ADDENDUM NO. 2

Whiteland Community High School Phase 2A
300 E. Main Street
Whiteland, IN 46184

PROJECT: Whiteland Community High School Phase 2a

DATE OF ADDENDUM: May 2, 2024

801

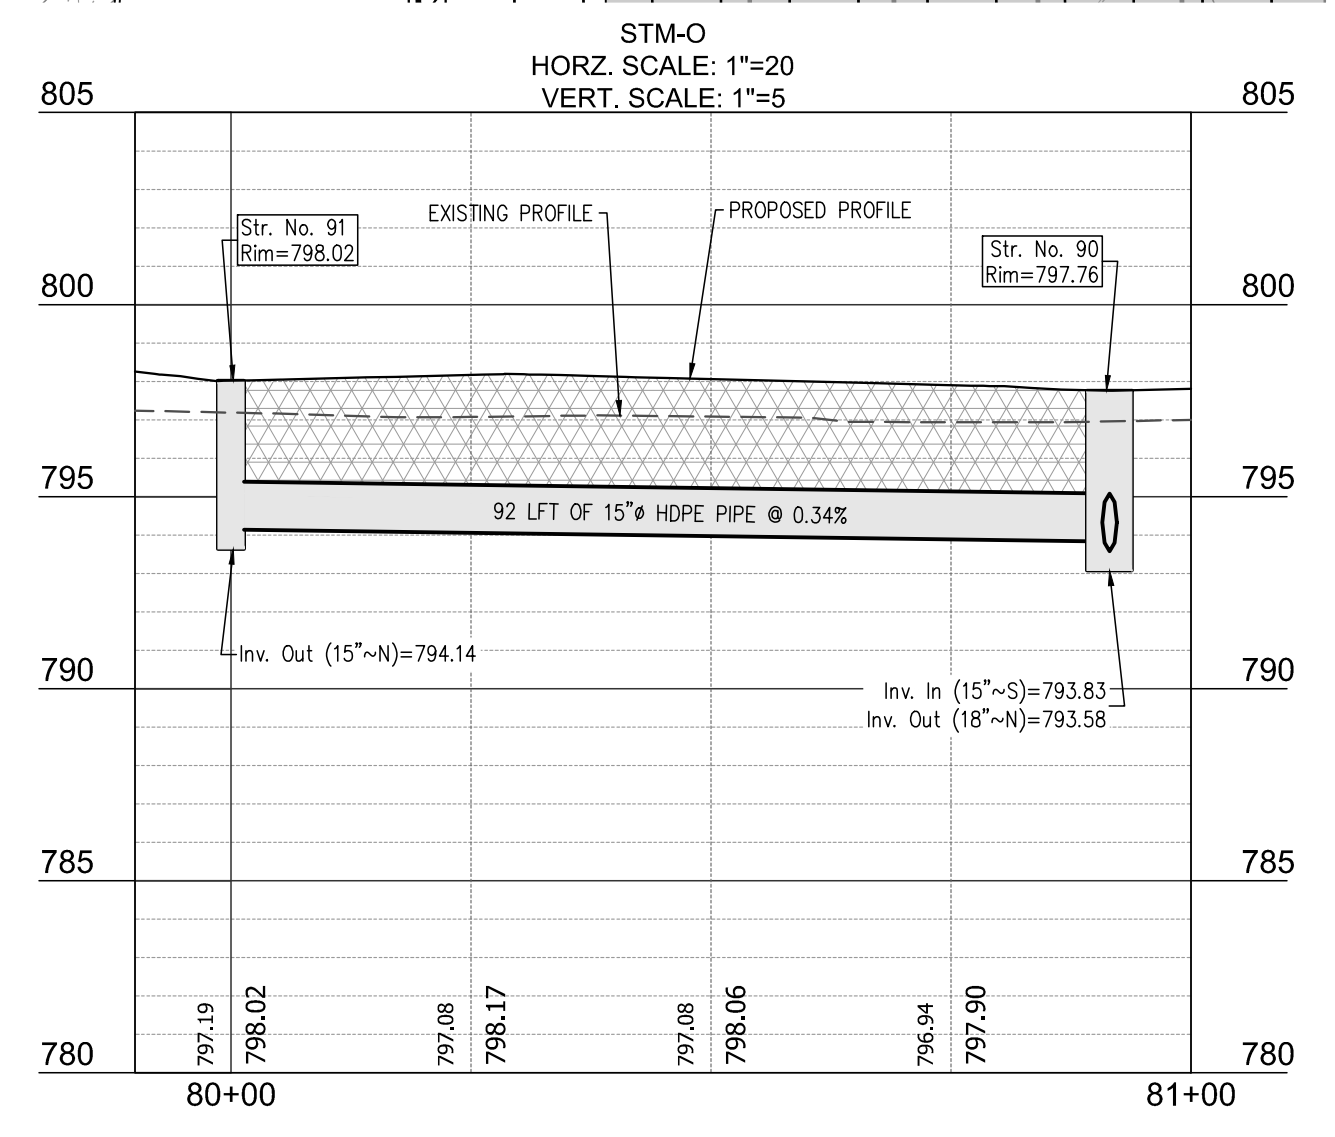
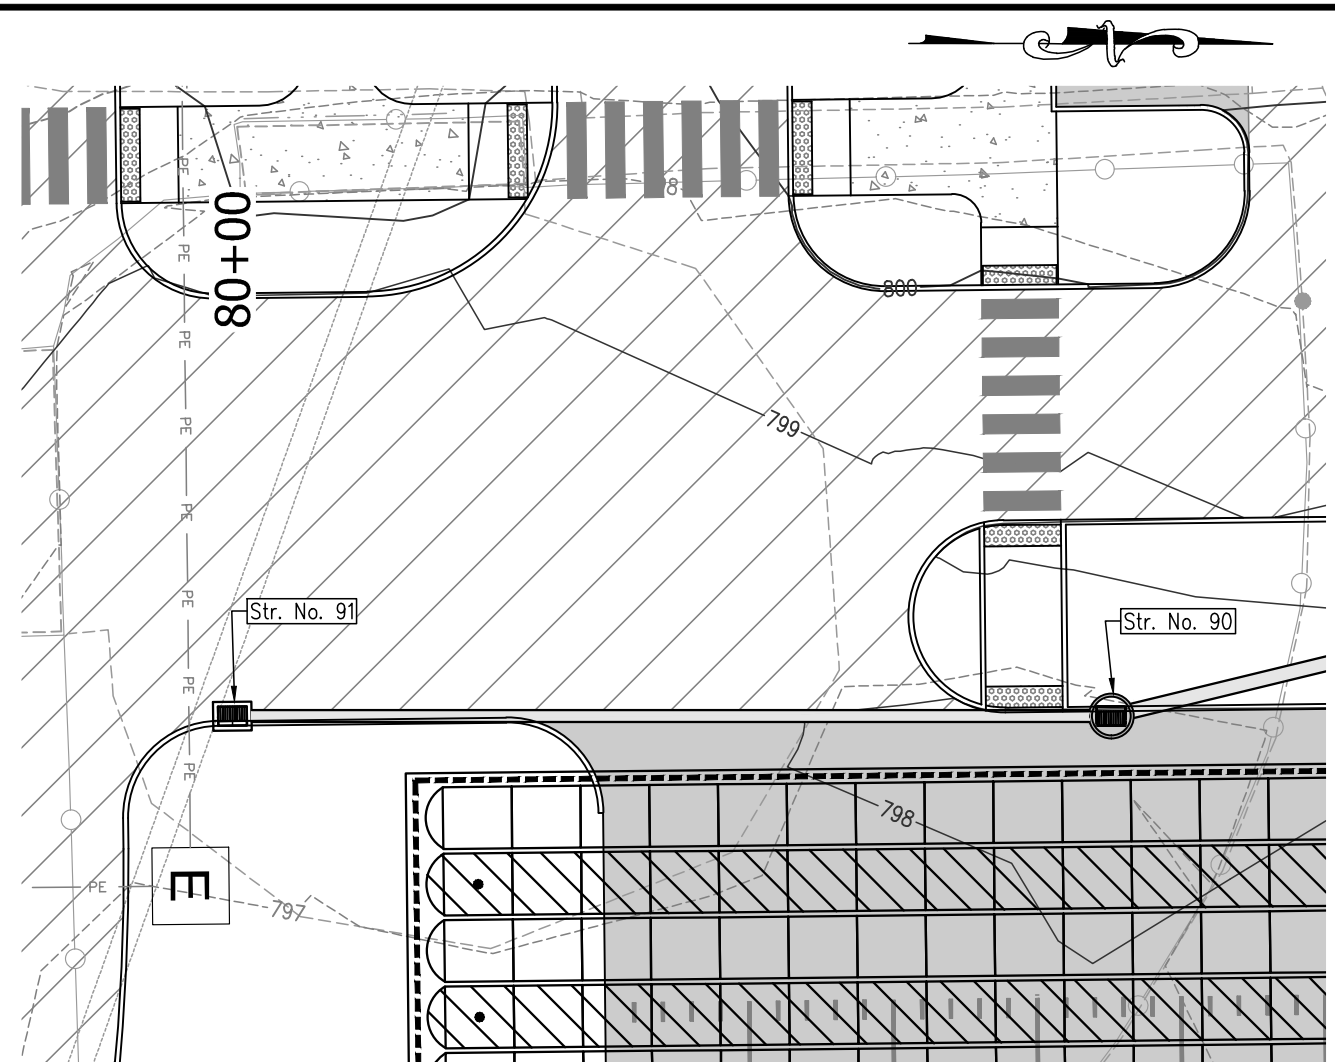
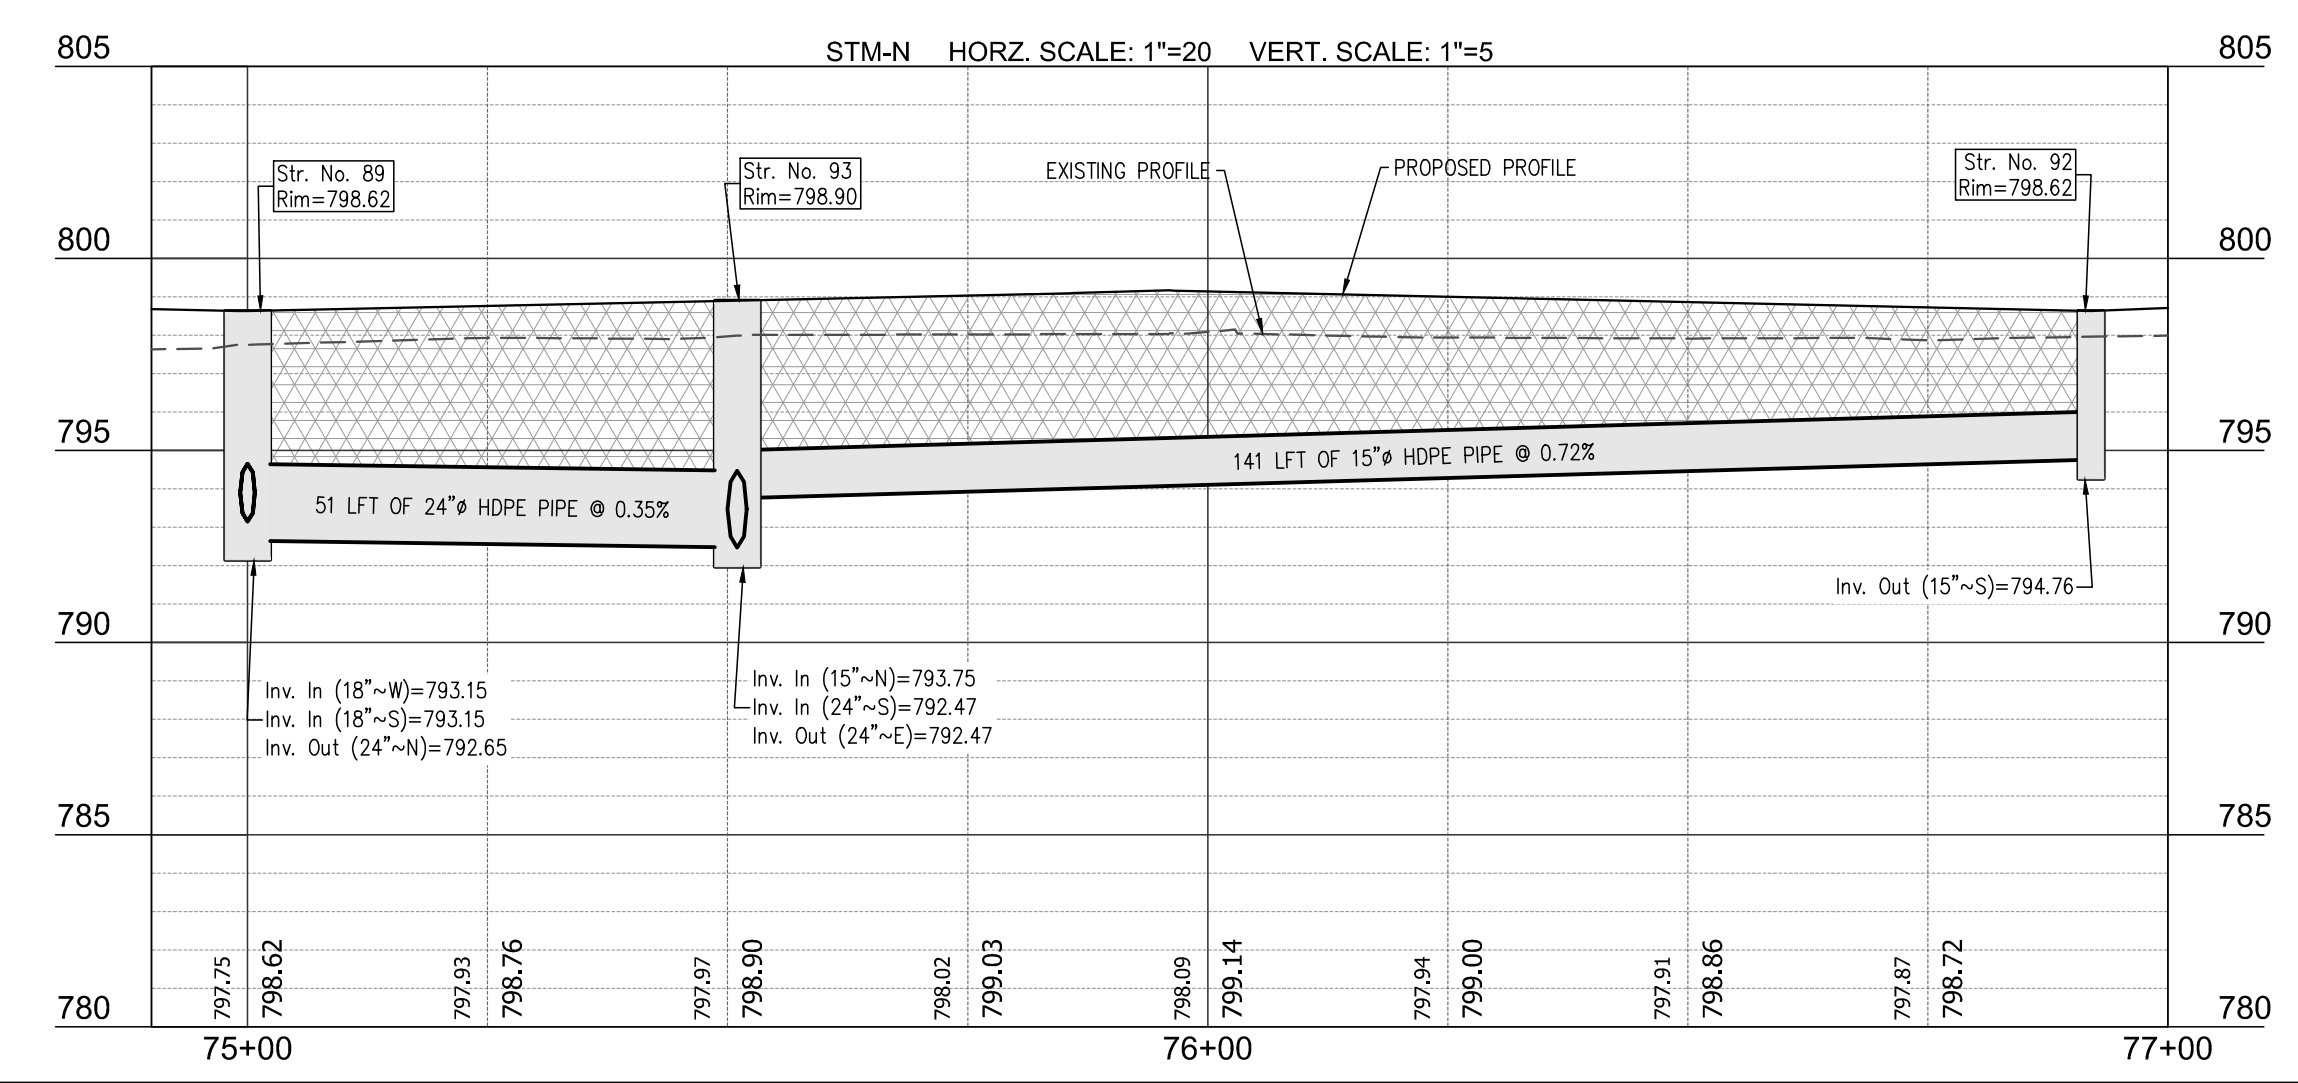
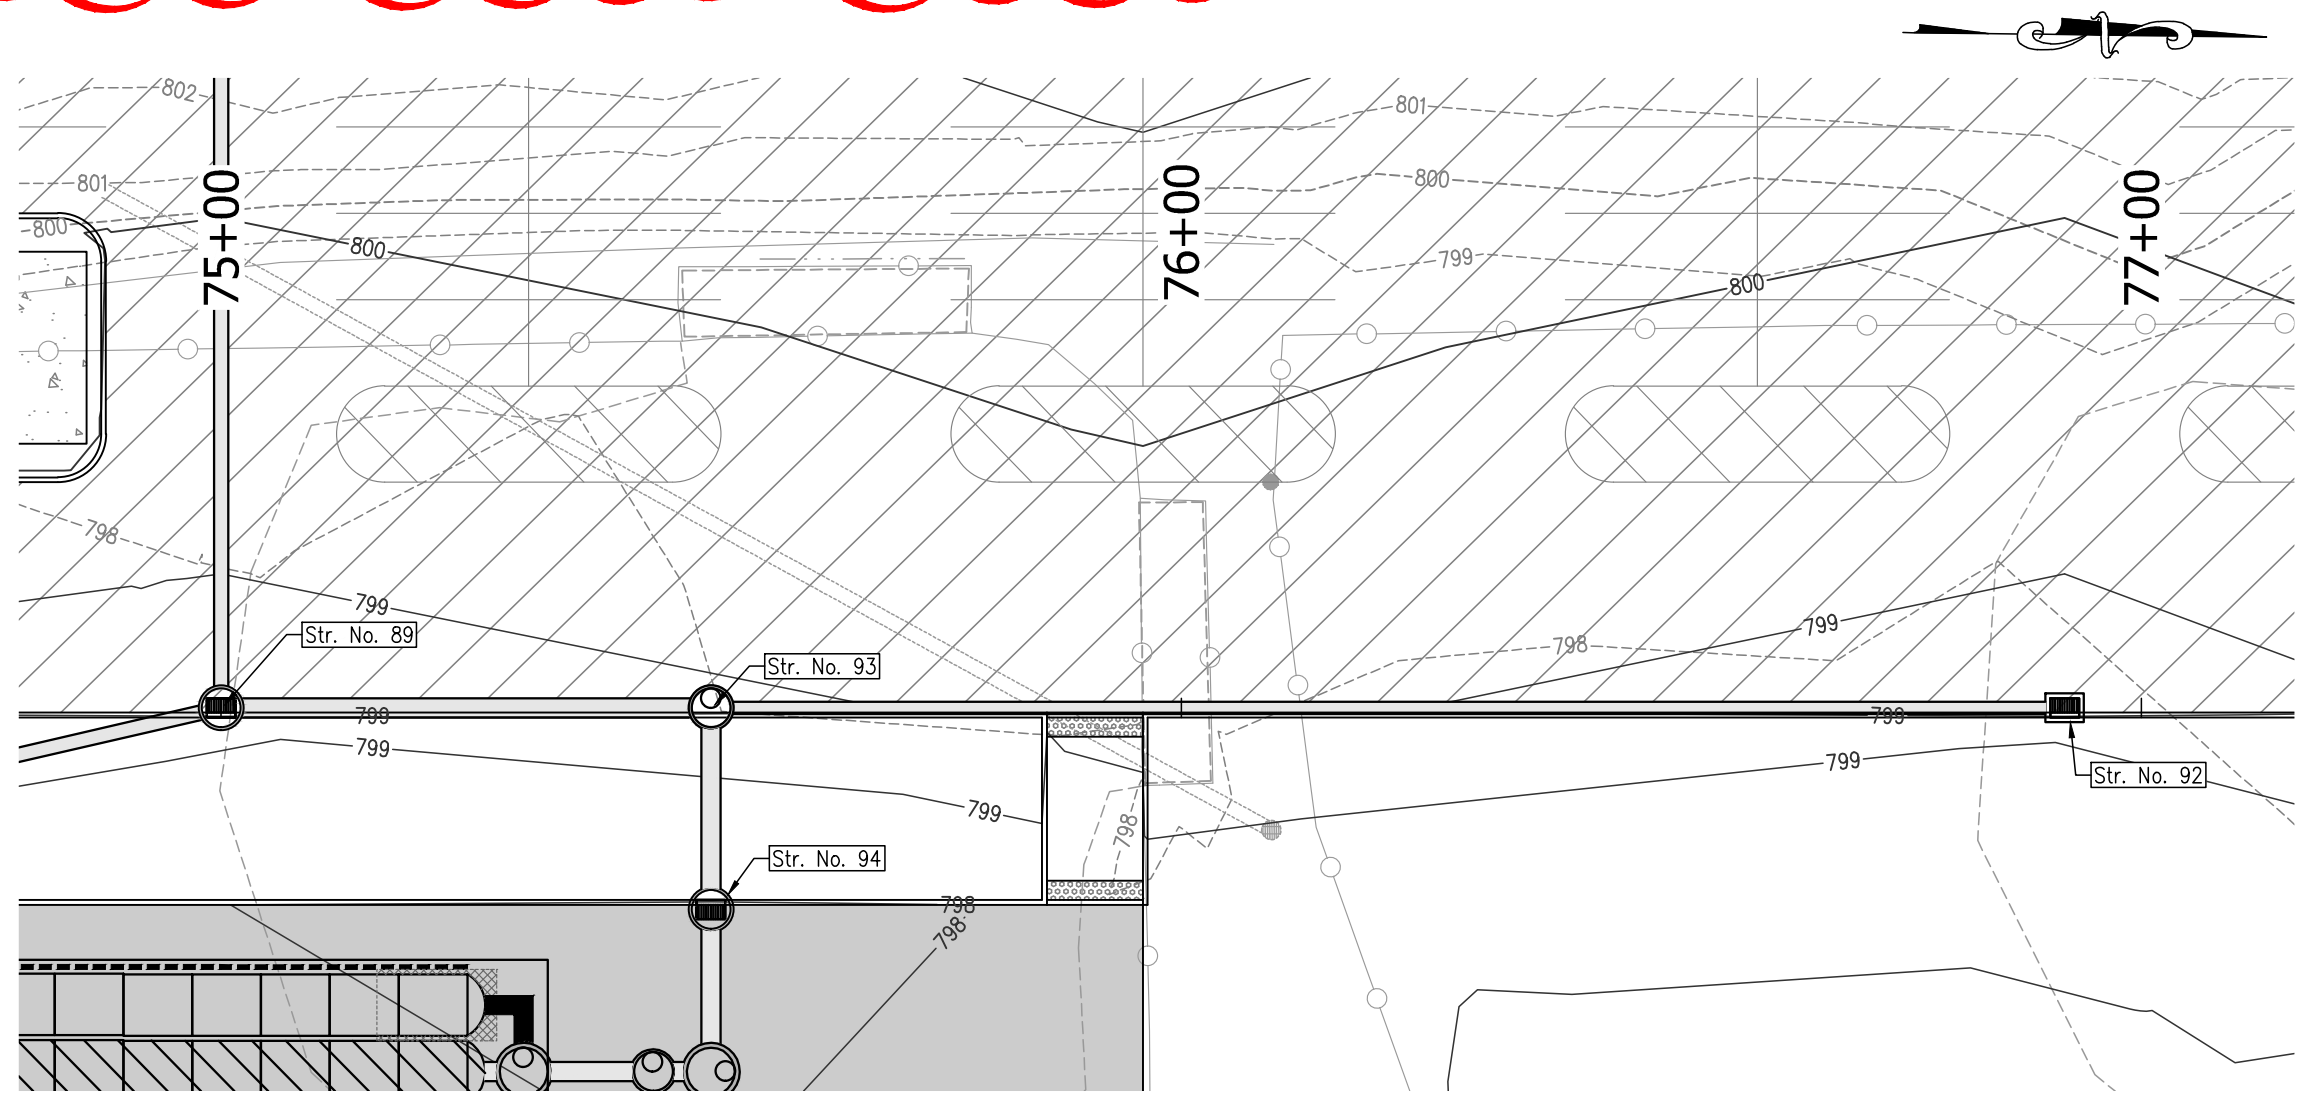
- 14 Storm Plan and Profile (sheet 801):**
 - o Str. No. 85 – reduced pipe size to 12” HDPE and revised invert elevation as shown.
 - o Str. No. 86 – revised invert elevations as shown.
